HIGHLAND PARK EXTENSION SUBDIVISION, **RESUBDIVISION OF LOT 17**

APPLICATION NUMBER 13 DATE November 6, 2003
APPLICANT Highland Park Subdivision, Extension 2, Resub of Lot 17
REQUEST Subdivision

HIGHLAND PARK SUBDIVISION, EXTENSION 2, RESUBDIVISION OF LOT 17

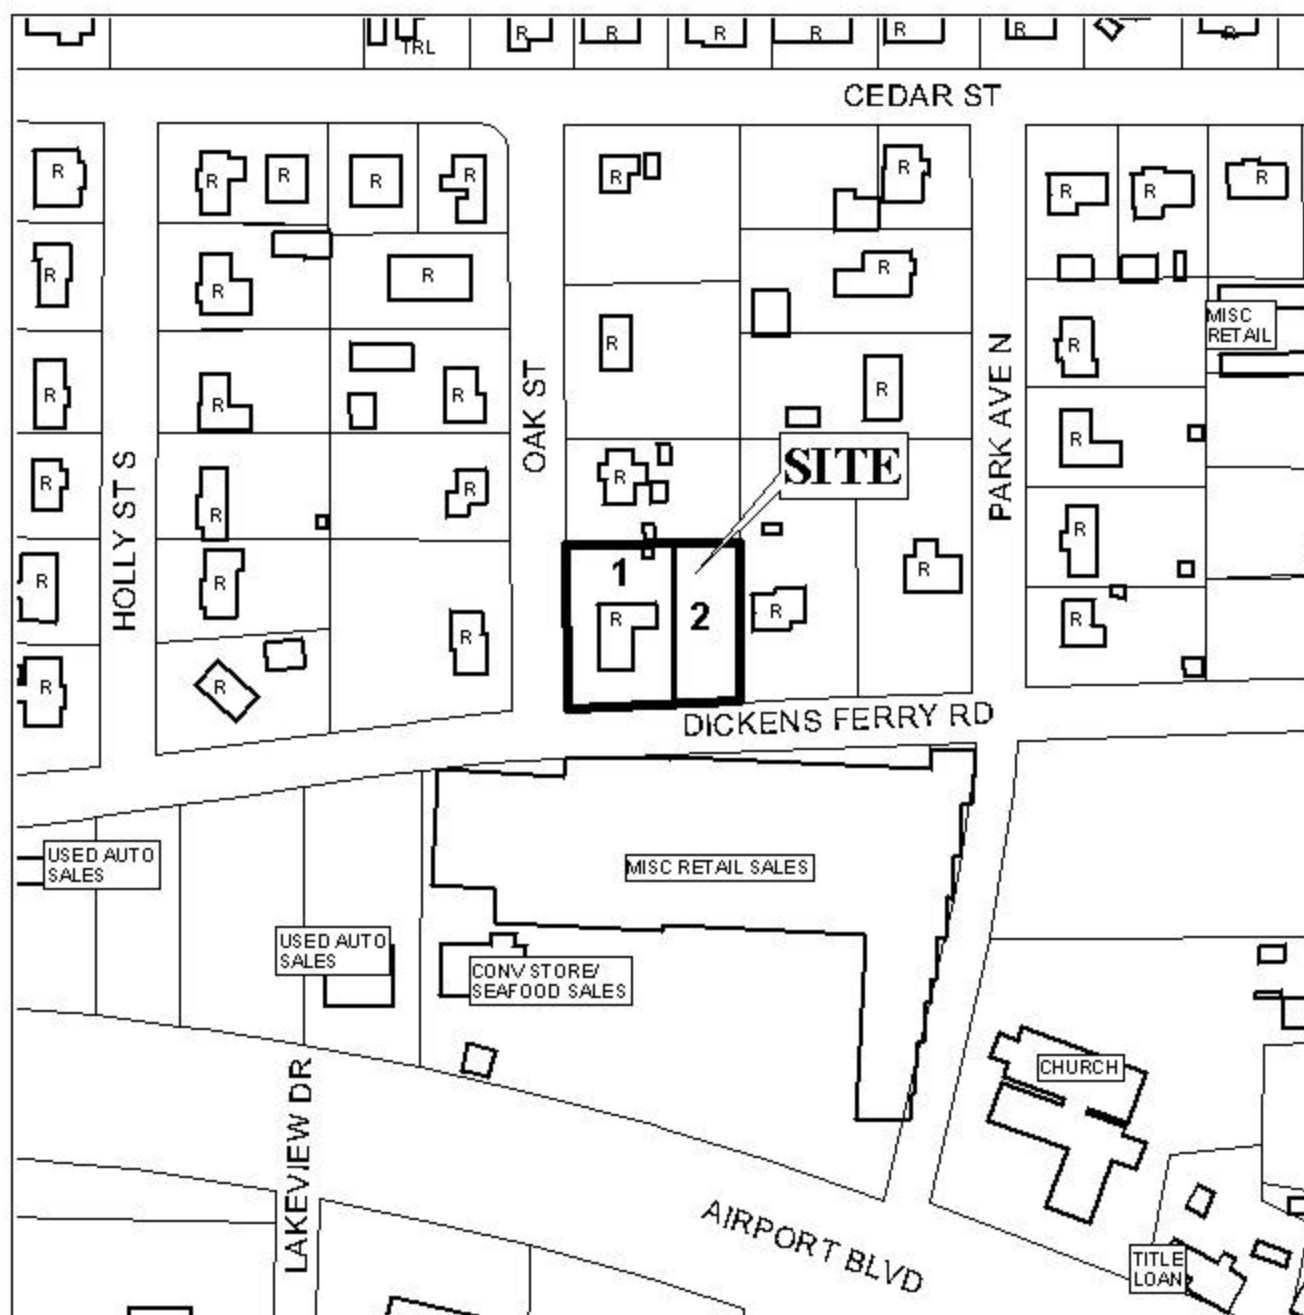
As a method of access management, the placement of a note on the final plat stating that Lots 1 and 2 are limited to one curb cut each, with the size, location and design to be approved by County Engineering, should be required. In addition, the placement of a note on the final plat stating that Lot 1 is denied direct access to Oak Street, should be required.

With Lot 1 being a corner lot, the dedication of a 25' radius should be required.

The 25-foot minimum setback lines are not shown but would be required on the final plat.

The plat meets the minimum requirements of the Subdivision Regulations and is recommended for Tentative Approval subject to the following conditions: 1) the placement of a note on the final plat stating that Lots 1 and 2 are limited to one curb cut each, with the size, location and design to be approved by County Engineering; 2) the placement of a note on the final plat stating that Lot 1 is denied direct access to Oak Street; 3) the placement of a note on the final plat stating that with Lot 1 being a corner lot, the dedication of a 25' radius should be required; 4) the placement of a note on the final plat stating that any lots which are developed commercially and adjoin residentially developed property must provide a buffer, in compliance with Section V.A.7. of the Subdivision Regulations; and 5) the placement of the 25-foot minimum setback lines on the final plat.
